HISTORIC DISTRICTS REVIEW BOARD FIELD TRIP

HISTORIC DISTRICTS REVIEW BOARD HEARING

SUMMARY INDEX
HISTORIC DISTRICTS REVIEW BOARD
August 26, 2014

MINUTES OF THE
CITY OF SANTA FÉ
HISTORIC DISTRICTS REVIEW BOARD

EXHIBIT "1"

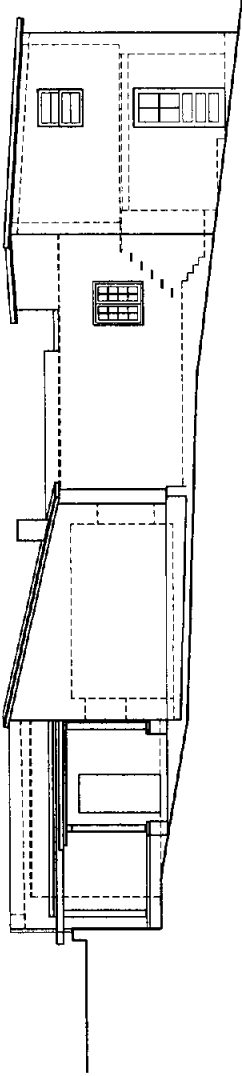
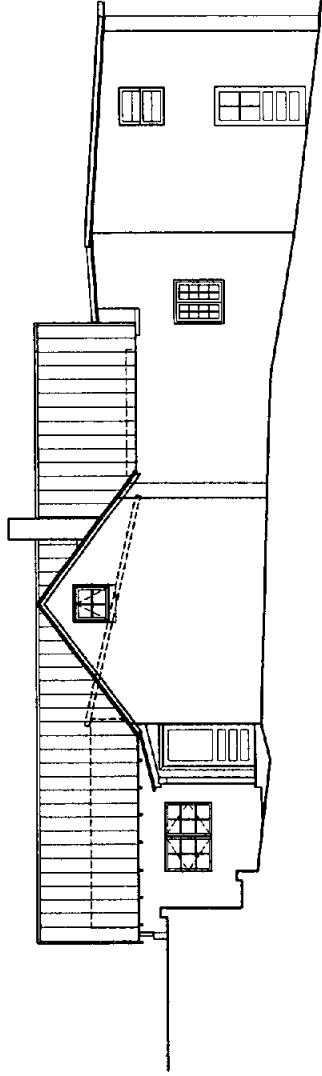
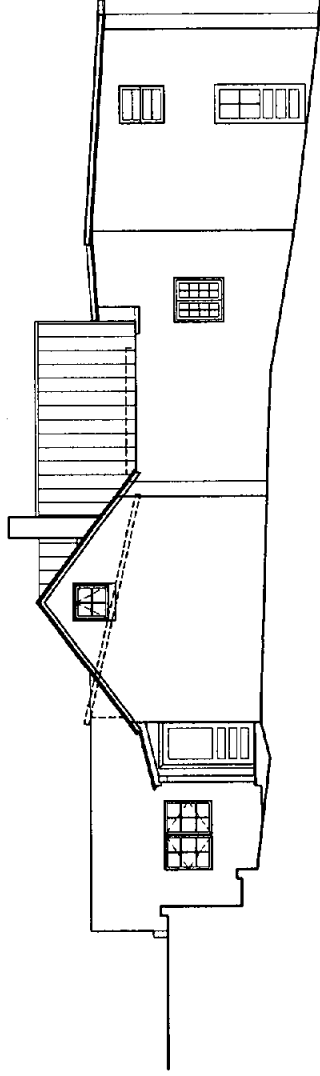
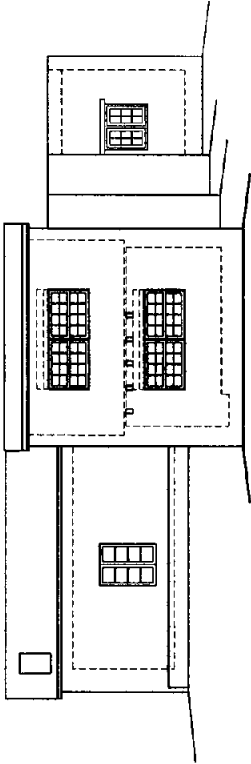
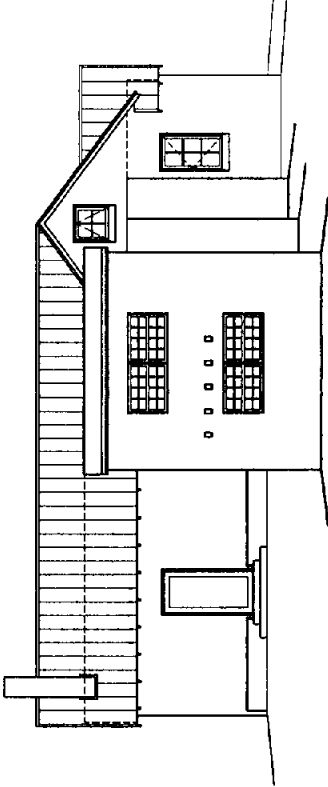
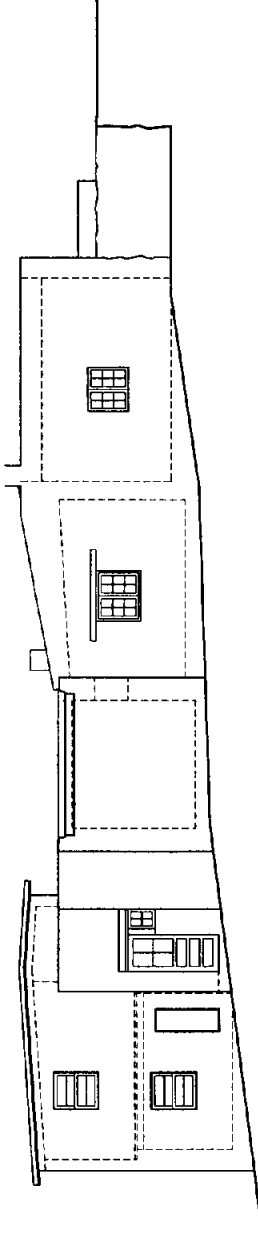
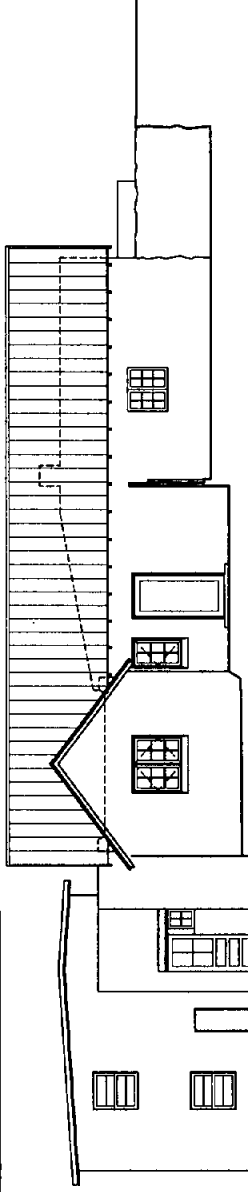
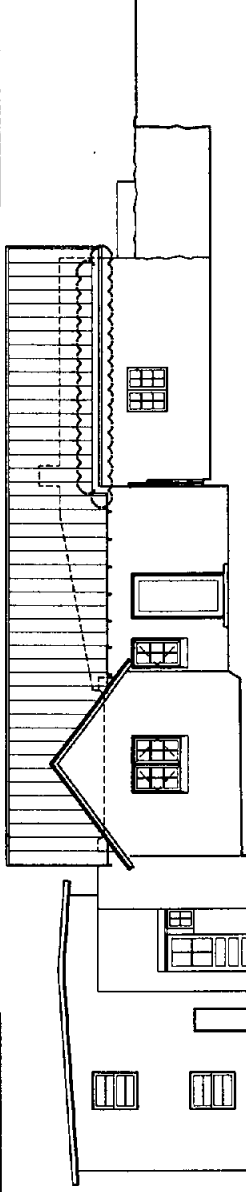
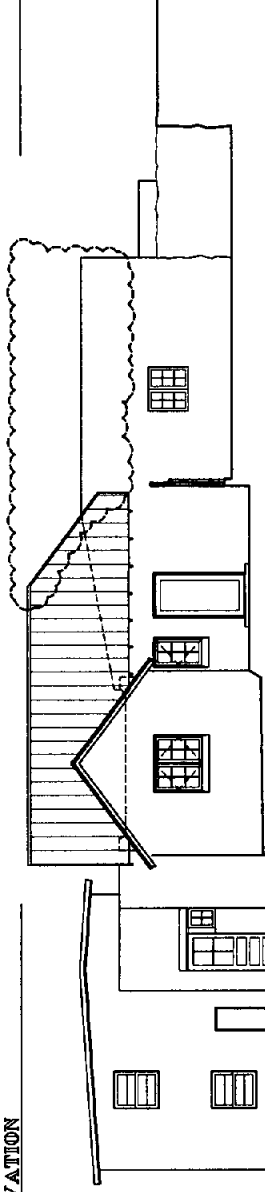
But then Mr. Vigil's son decided he was uncomfortable with that detail so Mr. Browne brought two alternative designs to the meeting that would not have an overhang on that property [attached to these minutes as Exhibit 1].

Mr. Browne was not sure how else to describe it. A roof plan would have helped. The L shaped roof was originally turned toward San Acacio and now goes the other way. It essentially becomes a hip at the corner.

Chair Woods said cutting the overhang off made it worse with a cut off pitch in the middle. She asked if he might want the Board to postpone this case to give him more time to consider it further. She also didn't know if the Board was comfortable with the contemporary detail.
